Subject: Request for Reconsideration of EPA's Final Carbon Pollution Emission Guidelines for Existing Stationary Sources: Electric Utility Generating Units (Clean Power Plan), Docket ID No. EPA-HQ-OAR-2013-0602

## **Wisconsin’s Request for Reconsideration of EPA’s Final Carbon Pollution Emission Guidelines for Existing Stationary Sources: Electric Utility Generating Units (“Clean Power Plan”)**

**Figure 1. Elm Road coal power plant generation**

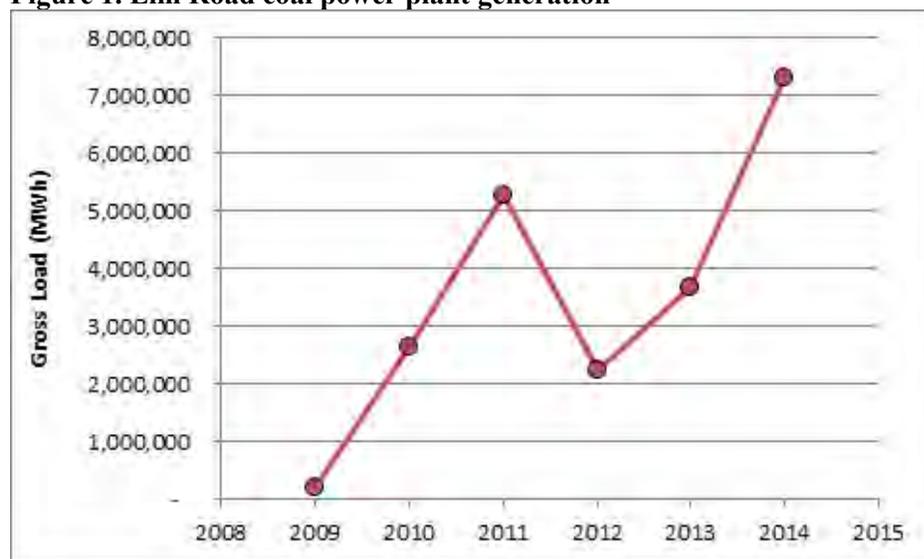
5.2. EPA did not adjust Wisconsin’s baseline to account for the operation of the Elm Road Generating Station

EPA must adjust Wisconsin’s baseline to reflect operations at the Elm Road Generating Station. Under the final rule, EPA adjusted the baseline information for certain EGUs if their heat input for 2012 was less than 25 percent of both its 2010 and 2014 totals and if the unit’s adjusted heat input was greater than 10 percent of the state’s total heat input. Based on information in EPA’s Clean Air Markets Division (CAMD) database, in 2014 the Elm Road plant accounted for approximately 15 percent of the heat input and generation for all fossil fuel plants in Wisconsin.<sup>15</sup> Therefore, Elm Road meets EPA’s criteria for adjusting the baseline based on 2014 data.

The Elm Road power plant began operations late in 2009. Upon startup, one of the units at Elm Road experienced technical problems preventing it from operating at its full capacity. As a result, in 2012, the plant was operating at 20 percent capacity.<sup>16</sup> After repairs were made, the plant continued to increase operations every year. EPA should not consider 2010 data for Elm Road, because this was the first year both units operated and is not representative of normal operations. This is particularly important because Elm Road is a modern, efficient plant that is likely to be dispatched at a high capacity factor in future years. Figure 1 shows the combined generation from the two coal fired units at the plant. This data shows that generation reached approximately 66 percent of capacity in 2014.
